#### **CONTRACT NO. 1765**

#### **CCTV INSPECTION OF ALCOSAN DROP SHAFTS**

#### ADDENDUM NO. 1

#### ATTACHMENT B ADDITIONAL DROP SHAFT PROFILE DRAWINGS

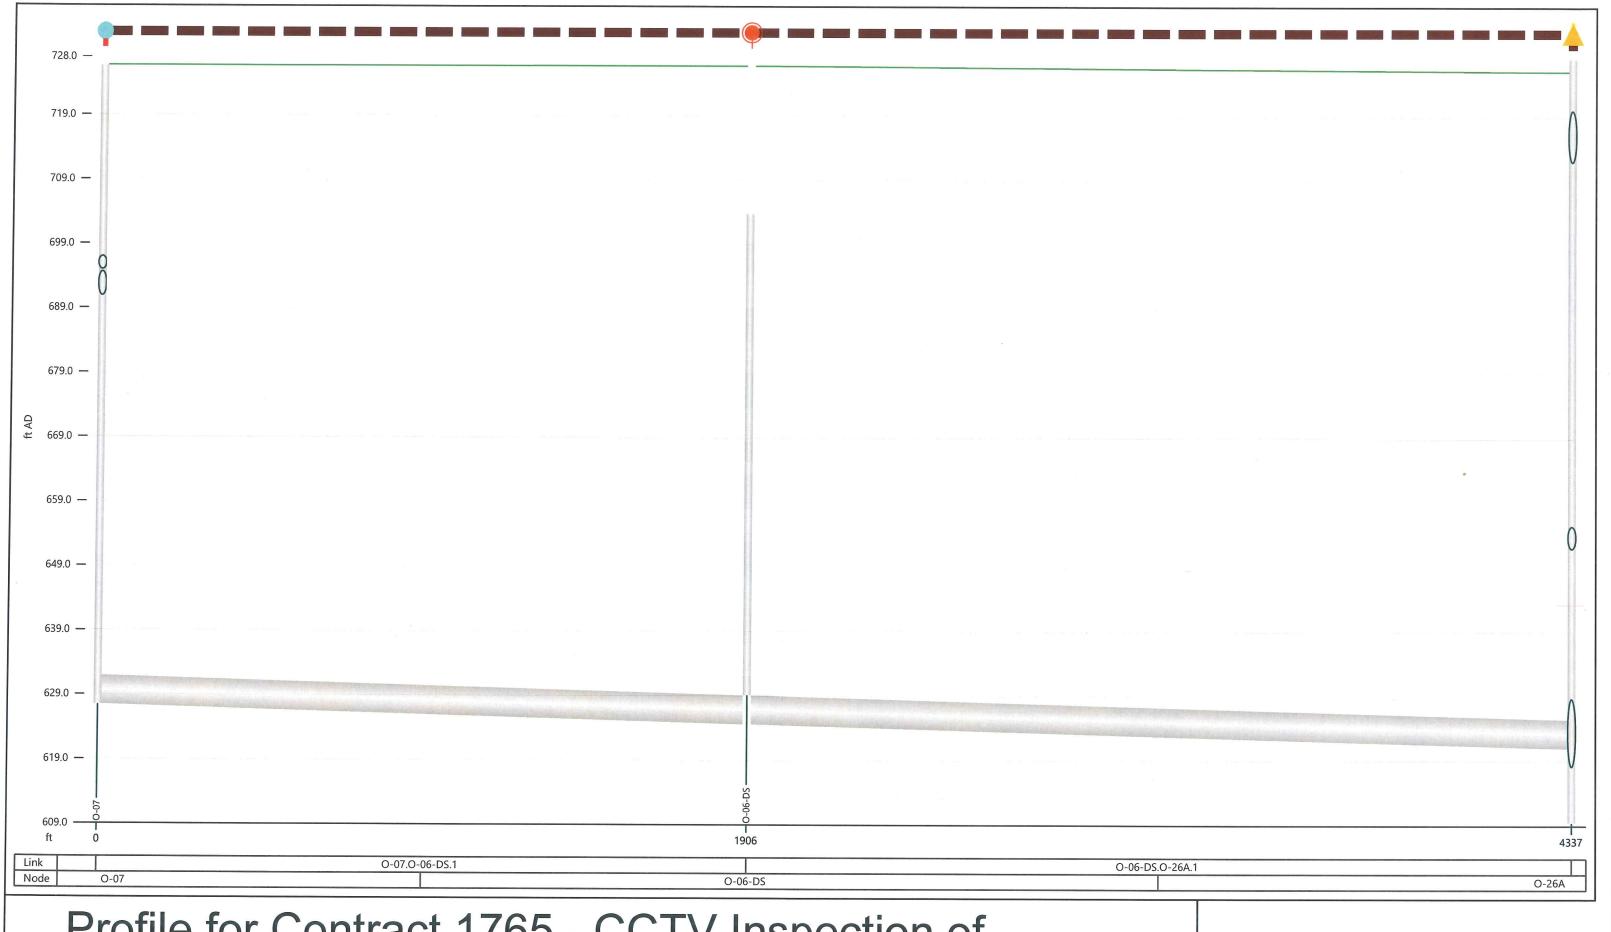
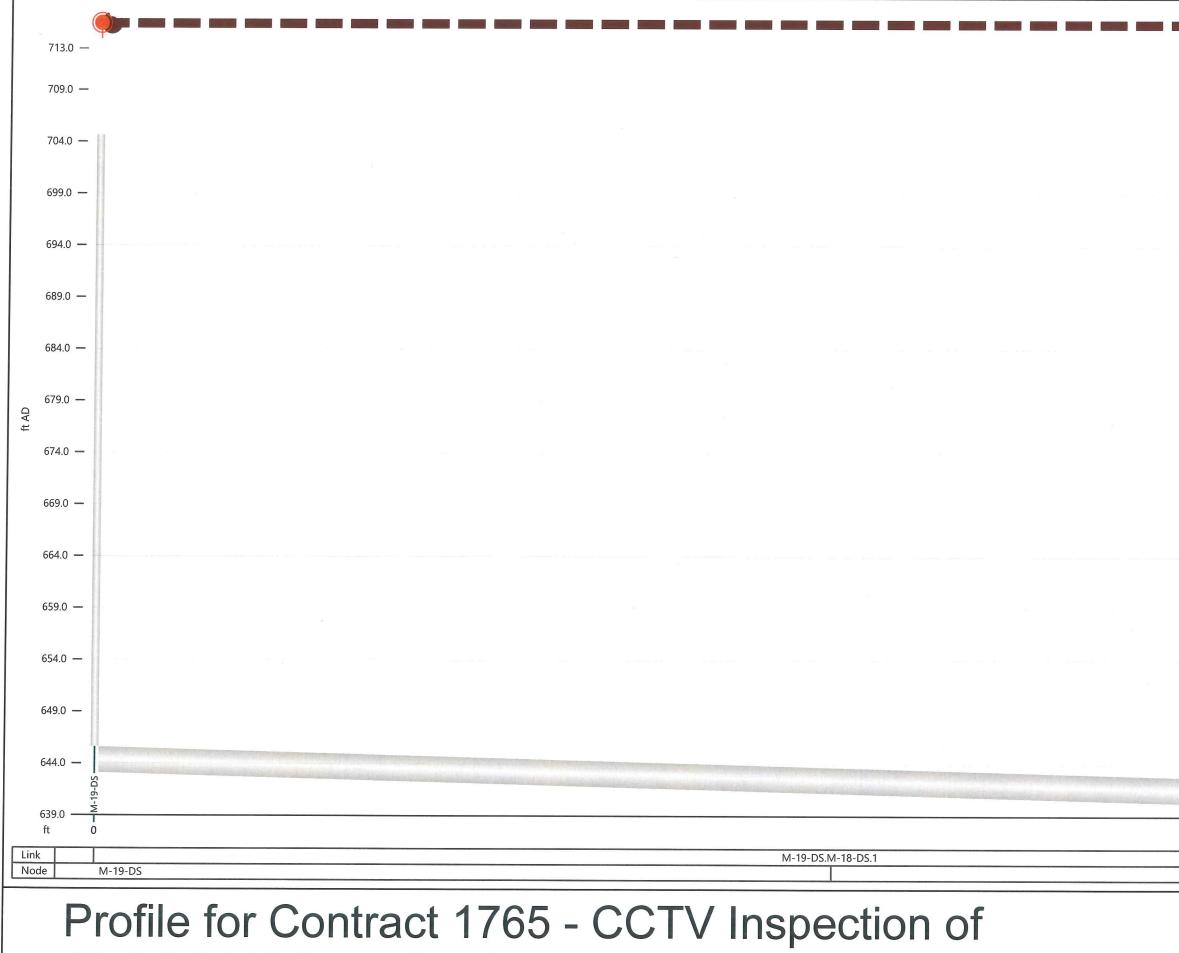
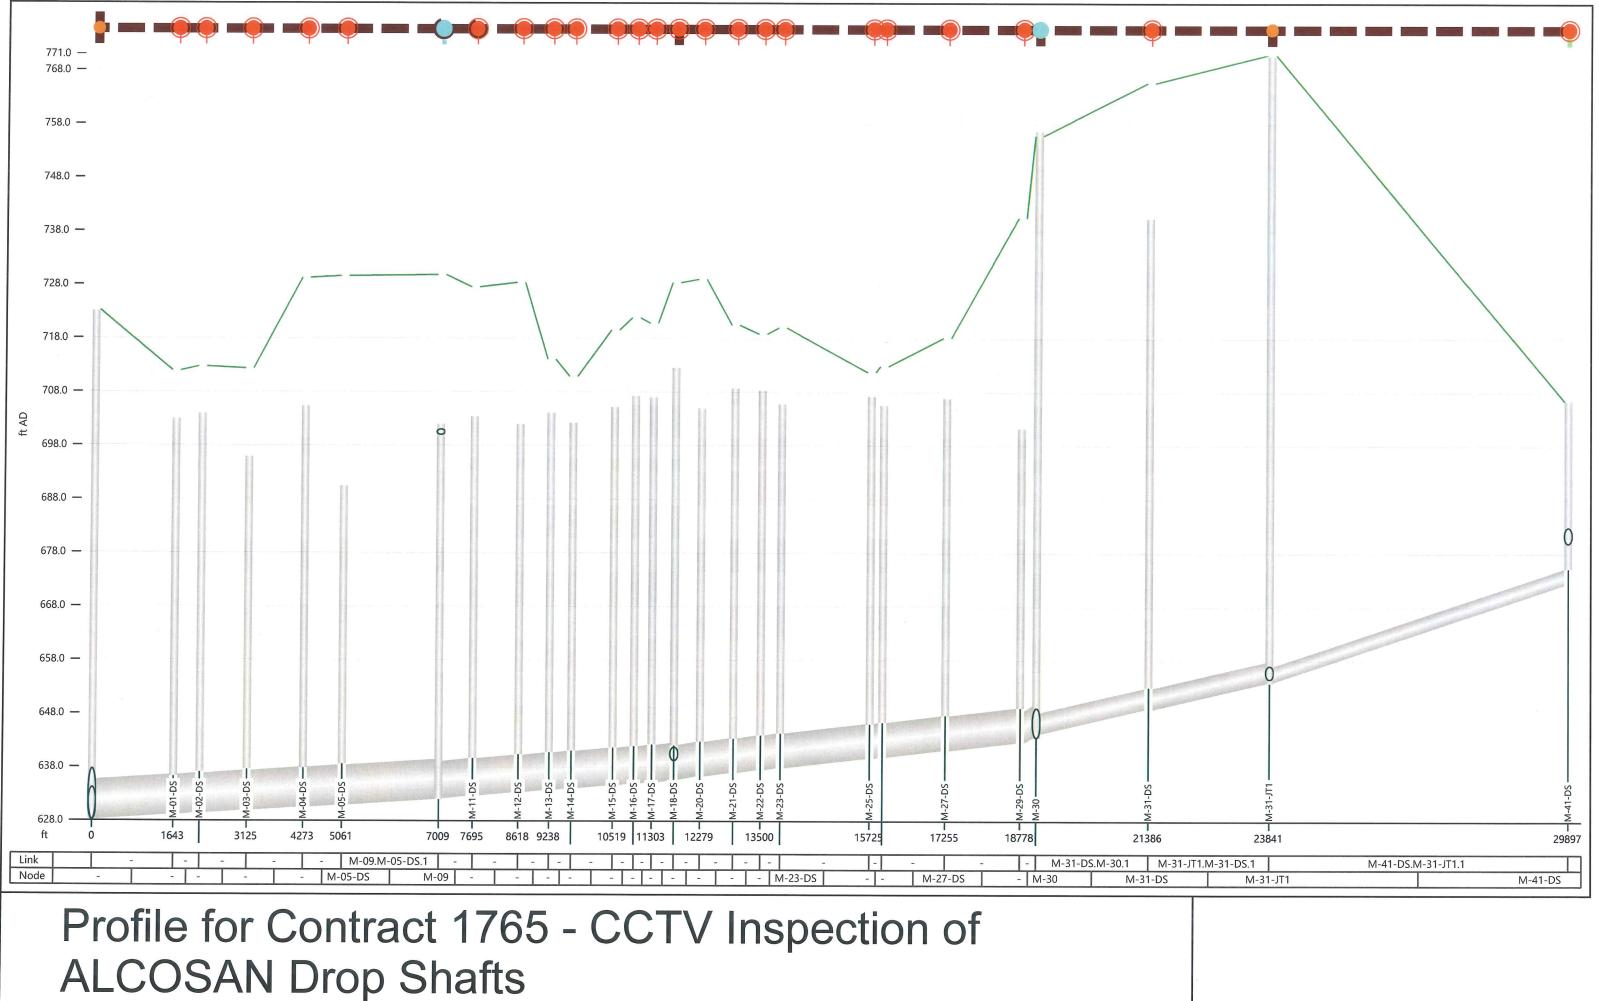
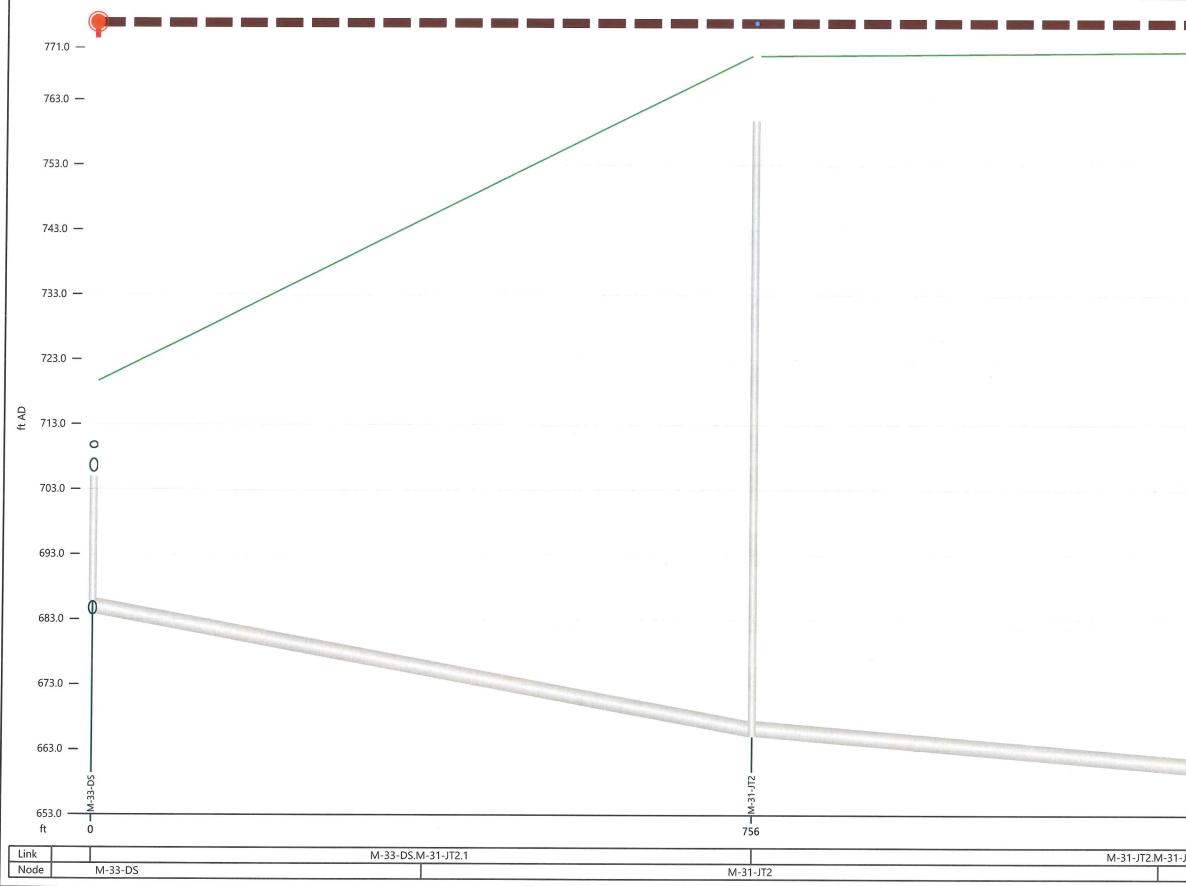
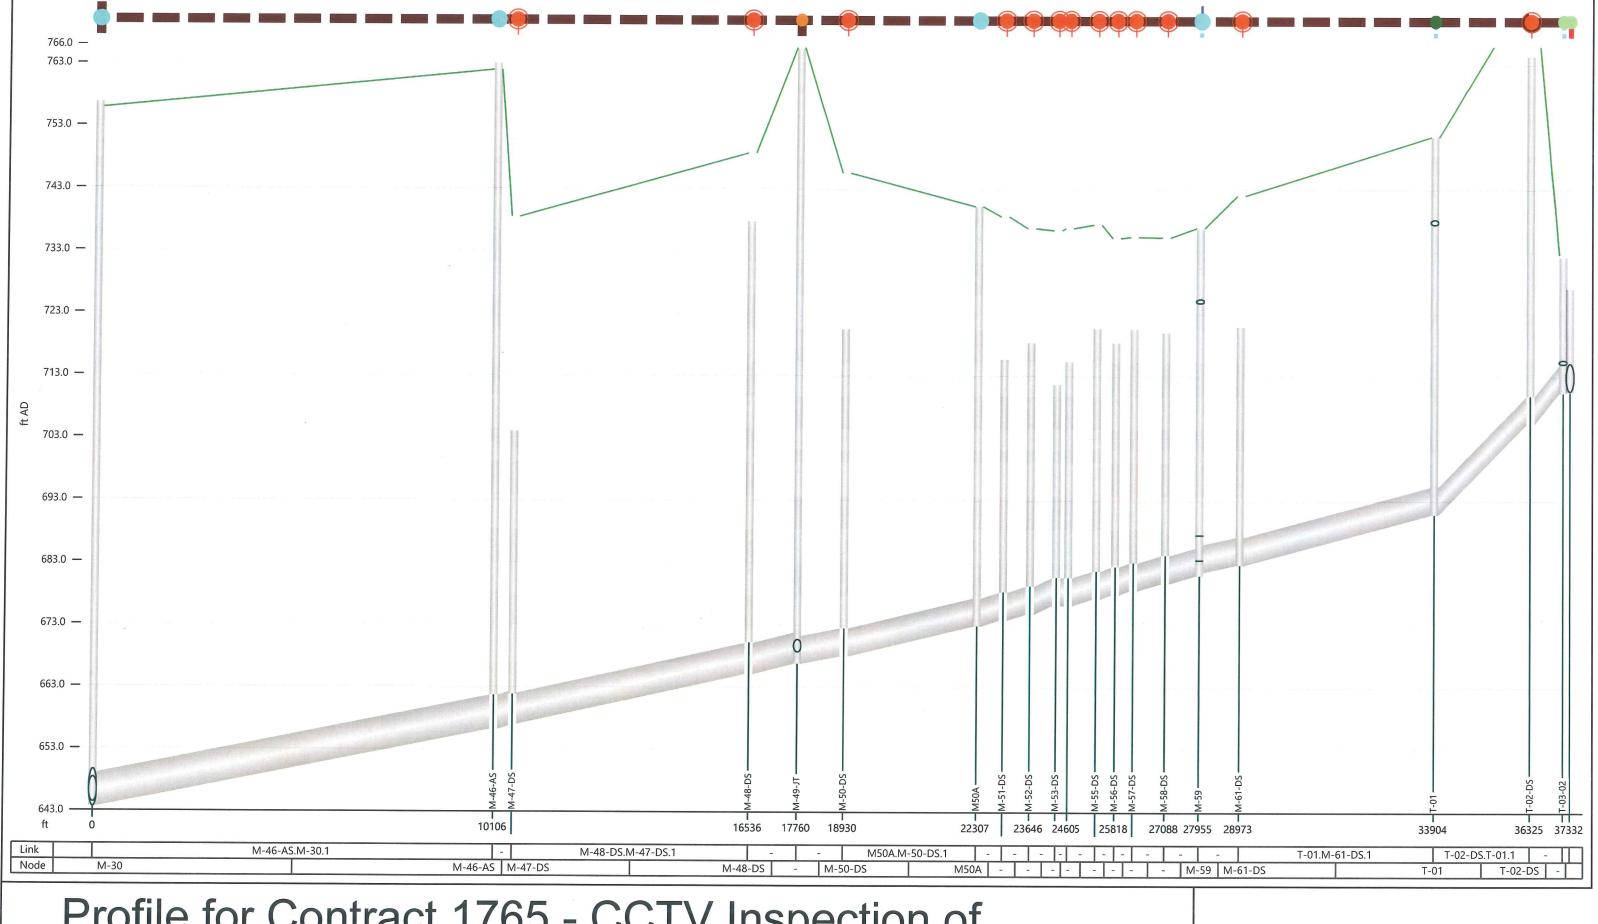
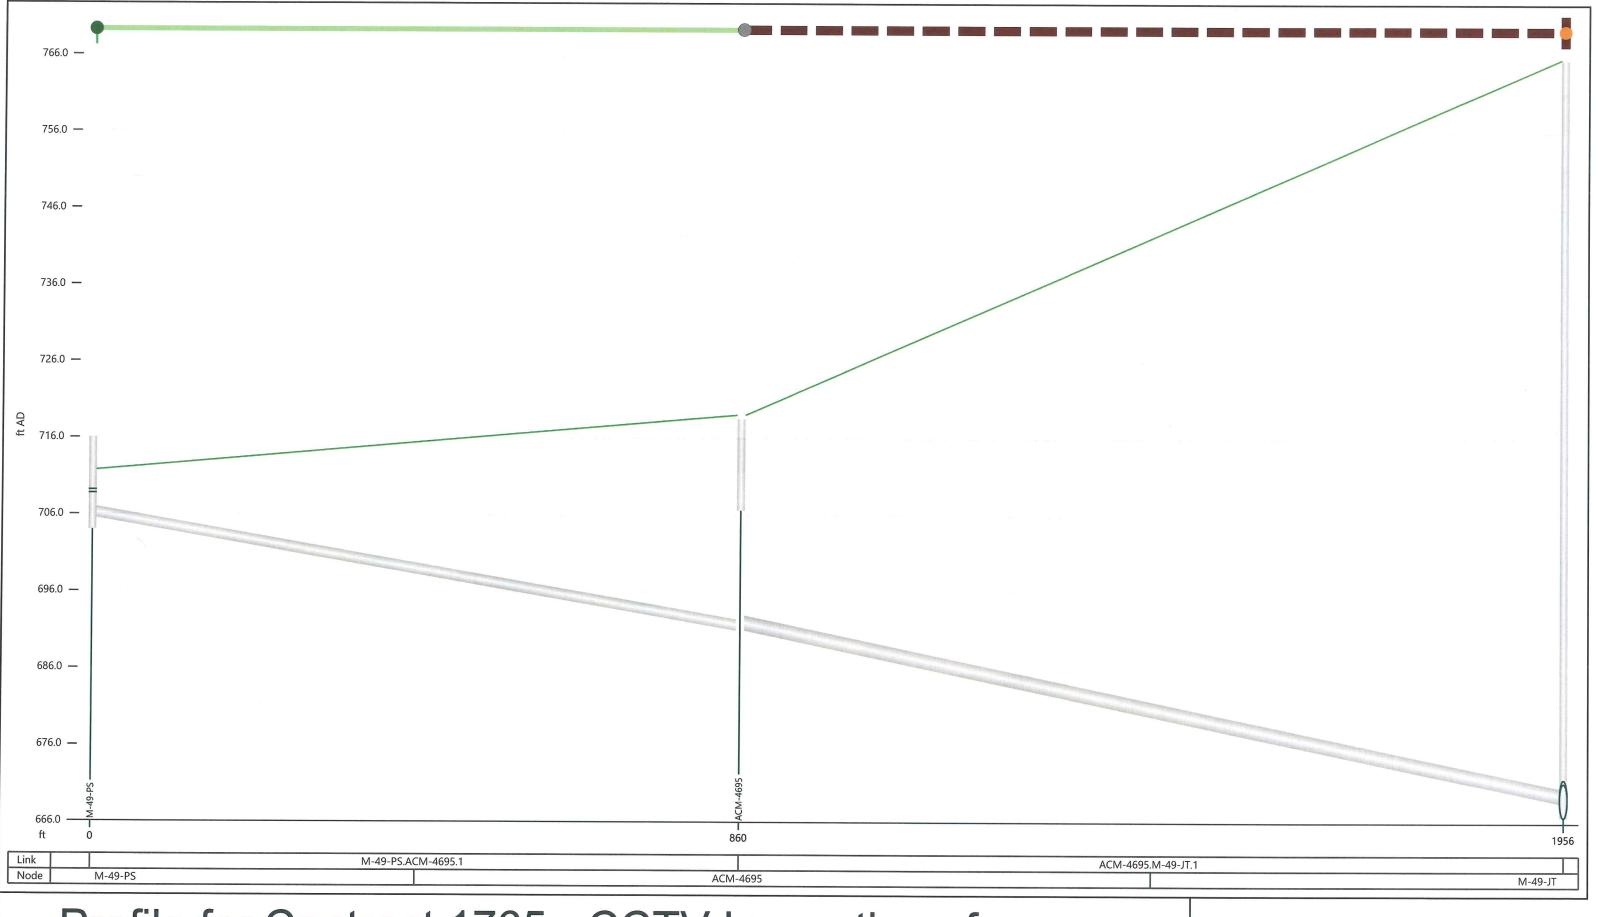
1. Add drawings "Profile for Contract 1765 – CCTV Inspection of ALCOSAN Drop Shafts." See Attachment B.
